**Medway DPW Water Quality Treatment  
Facility Site Plan – 19 Populatic Street**

**SUBJECT: Populatic Water Treatment Plant – Major Site Plan Review  
19 Populatic Street, Medway, Massachusetts**

Wright-Pierce has received Tetra Tech's comments on the Major Site Plan Review submission for the Populatic Water Treatment Plant project. We have prepared the following letter and attachments in response to these comments.

## TYPICAL SEWER MANHOLE

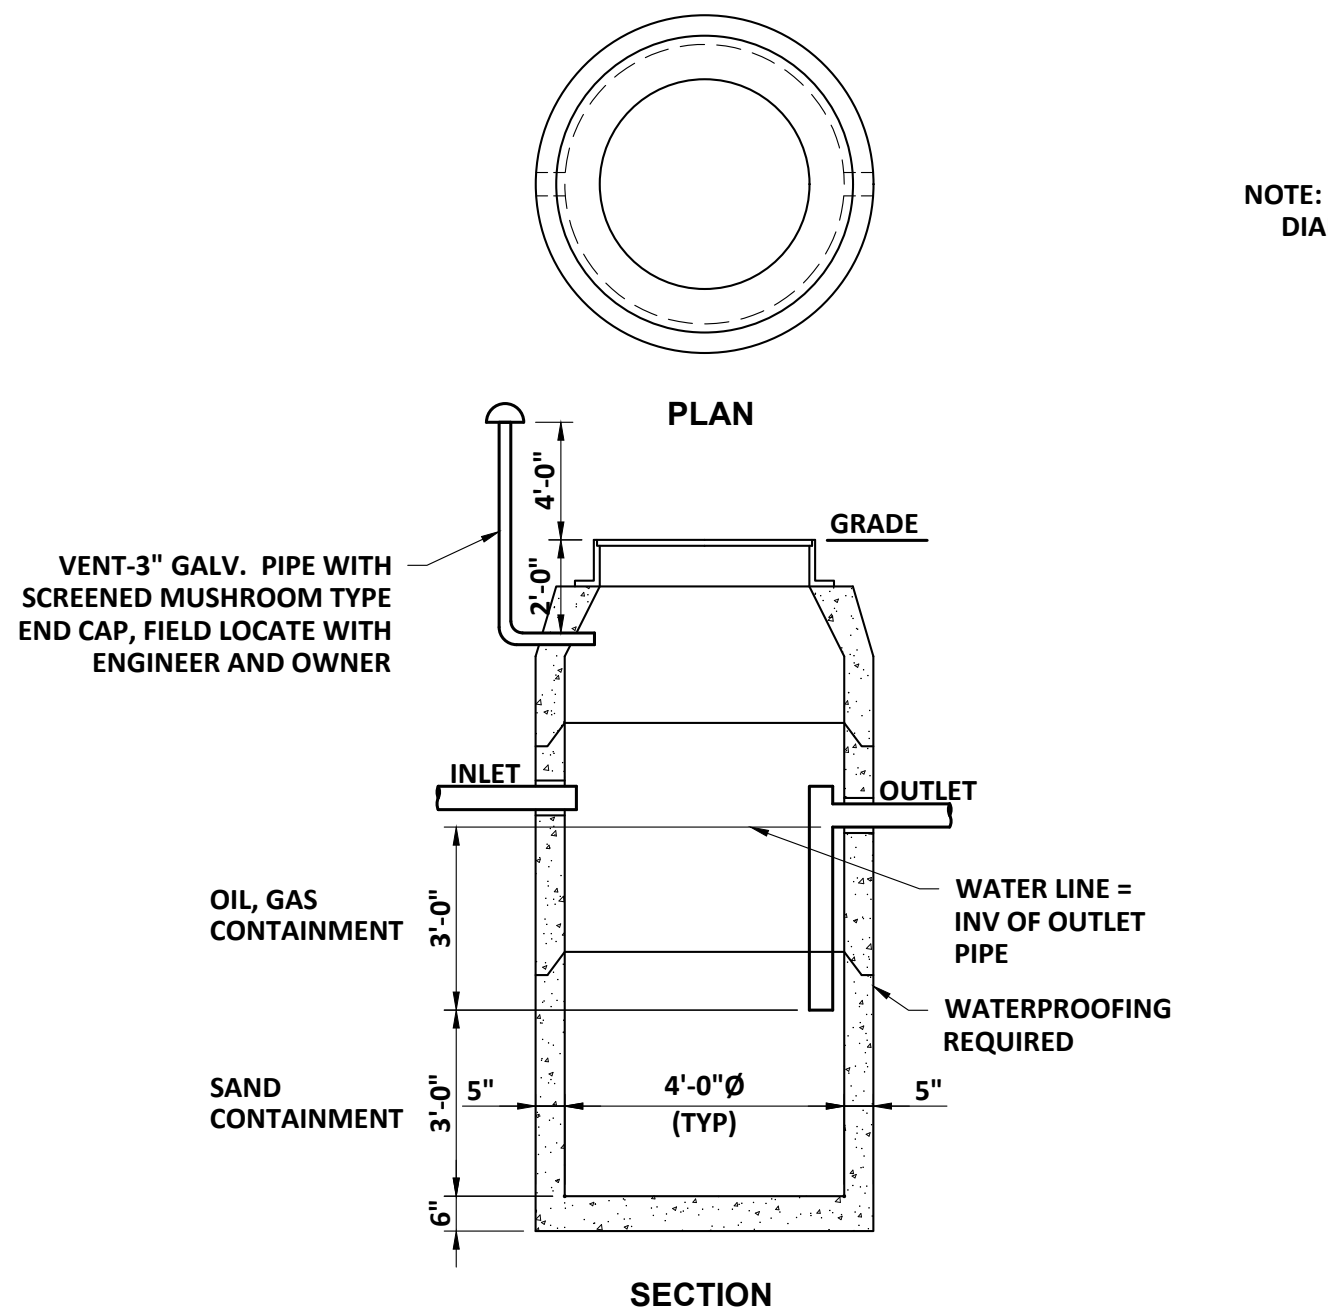
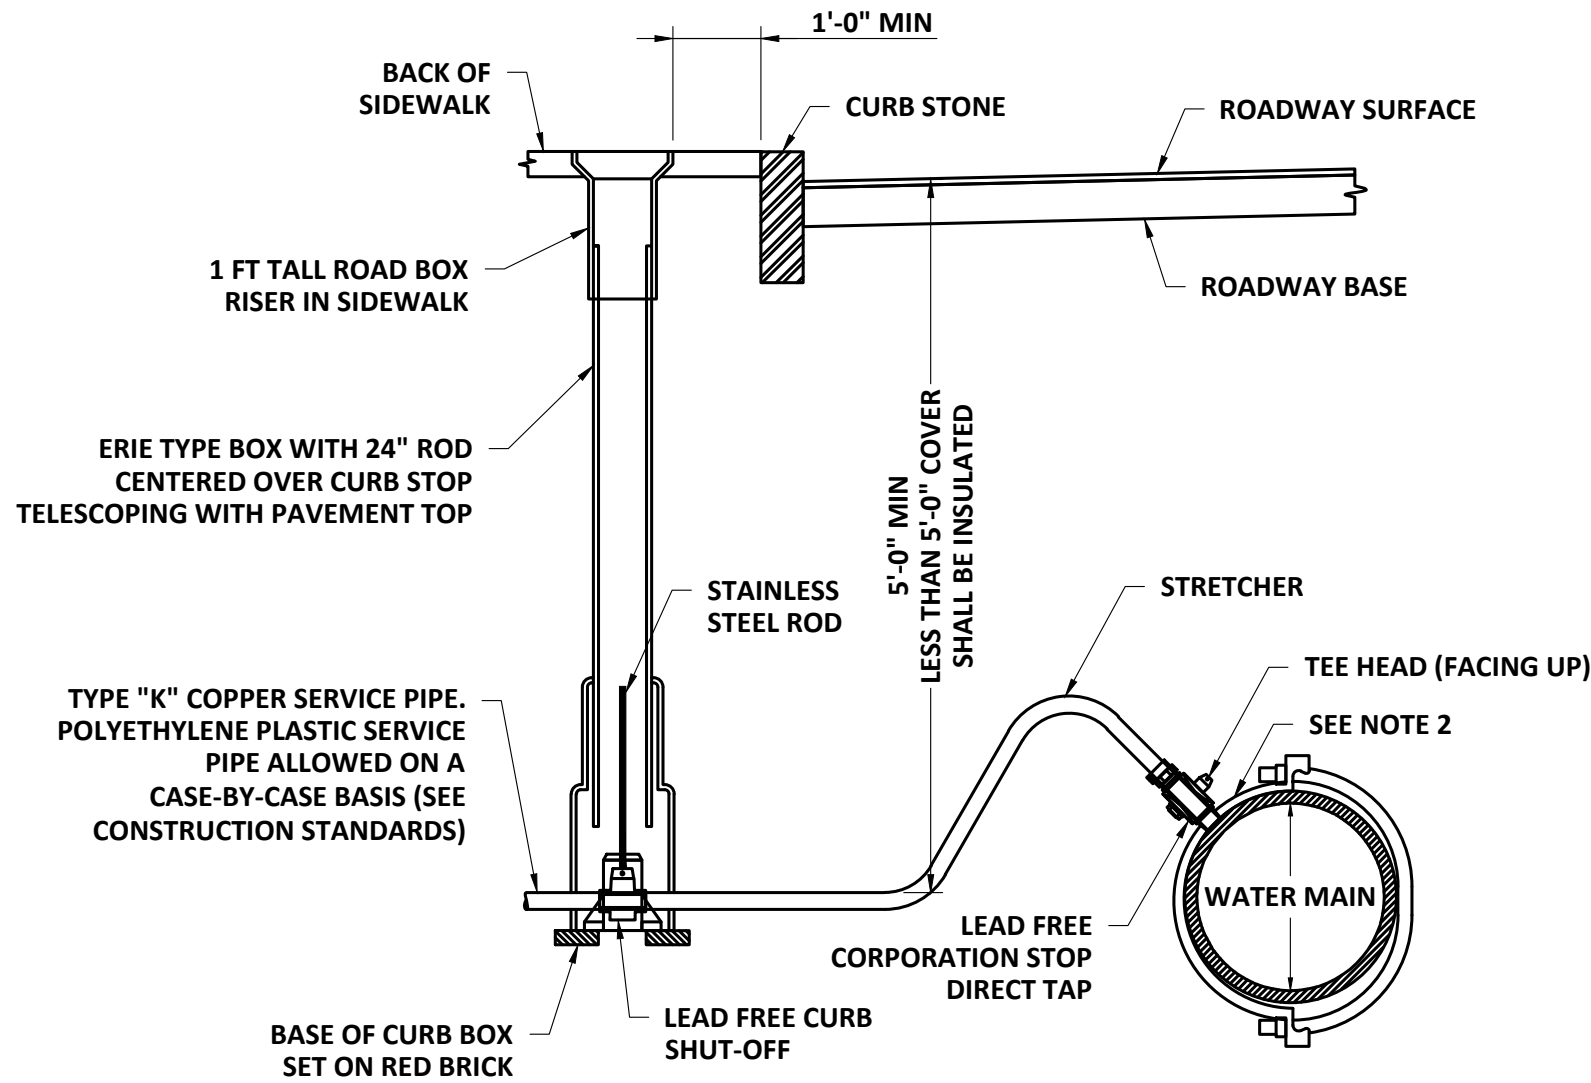
31. 31. The Applicant should add details for proposed 2-foot mow strip, sewer and drain manhole (not a standard 4-foot manhole for both as they have different requirements), concrete equipment pads and any other site amenity proposed on the Project.

***Response: Details have been updated on the revised drawing set. Refer to Attachment C***

SITE LIGHTING PLAN  
SCALE: 1"=20'

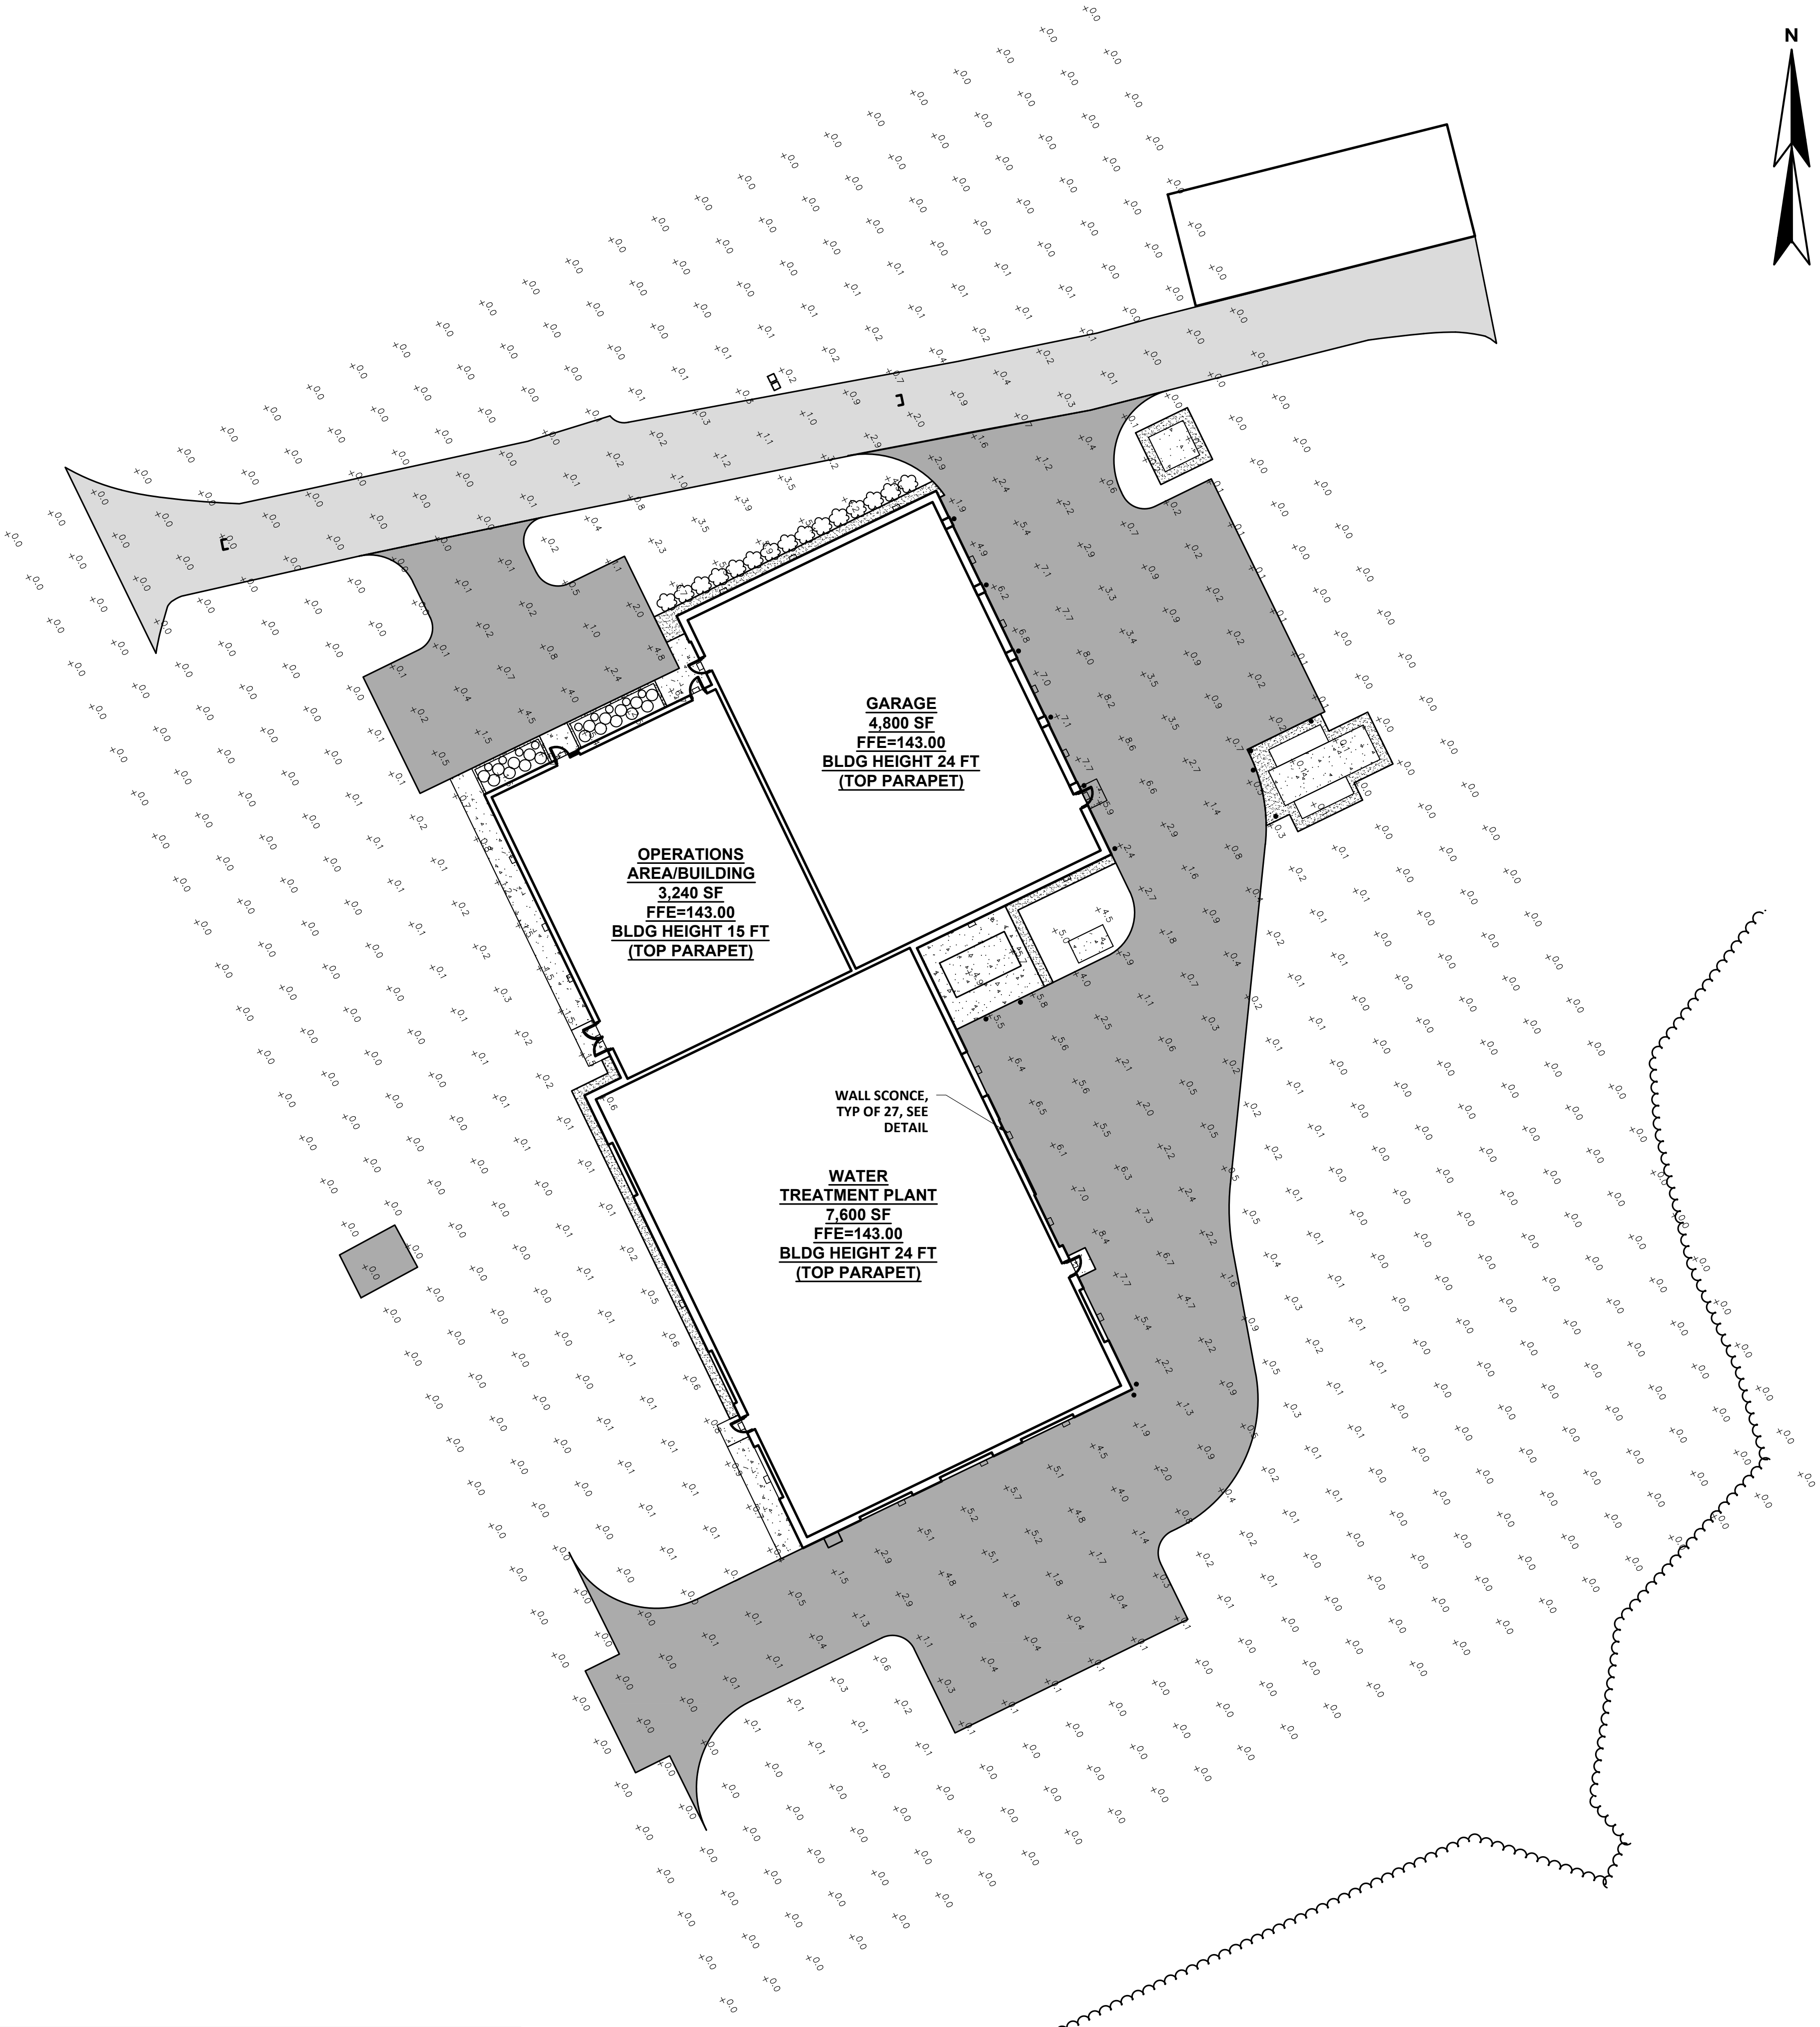
14. The Applicant has provided a lighting plan showing 26 proposed light sources connected to the building with no proposed light trespass on abutting properties. Height of luminaires should be specified along with the hours of illumination. TT also recommends the lighting symbols be better represented on the lighting plan as it is hard to determine the location of each proposed lamp. (Ch. 200 §204-5.D.15)

***Response: The lighting plan C-11 has been updated to include hours of illumination. Proposed lighting will be photocell controlled and illuminated from dusk until dawn. The height of luminaires are approximately 17' on the garage and treatment building areas and approximately 12' on the operations building area. They are also***

*shown on Sheet A-201. The photometric plan shows no light spillover onto Populatic Street or adjacent properties. Refer to revised drawings in Attachment C.*
